FW: Webform submission from: Western Sydney Aerotropolis Planning Package
Wednesday, 26 February 2020 11:27:46 AM

Western Sydney Aerotropolis Planning Package – submission to draft Western Sydney Aerotropolis Plan – impact on Lot [REDACTED] DP [REDACTED] / [REDACTED] Badgerys Creek

Figure 1 – Structure Plan and location of [REDACTED] Badgerys Ck (site [REDACTED])

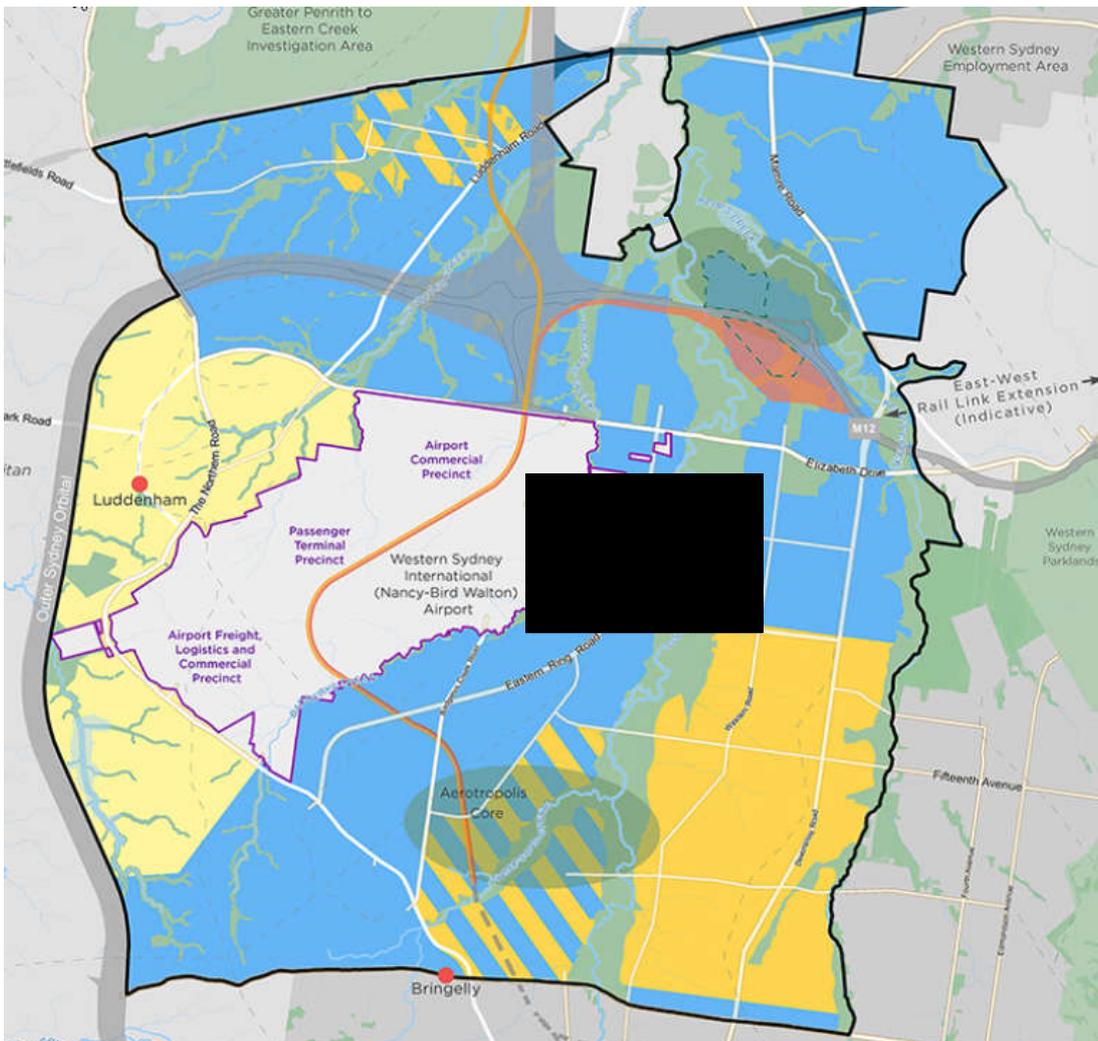
This submission to the draft Aerotropolis Plan is prepared on behalf of Mr David Vella and his family as owners of land at [REDACTED] Badgerys Creek. Refer to **Figure 1** showing the location of this site in relation to the Structure Plan for the Aerotropolis.

As shown on the Structure Plan, the subject site is within the area affected by the Western Sydney Aerotropolis Plan. The site is a regular rectangular rural-residential block with a frontage of 160m to Martin Road, depth of 250m and an area of approximately 4ha.
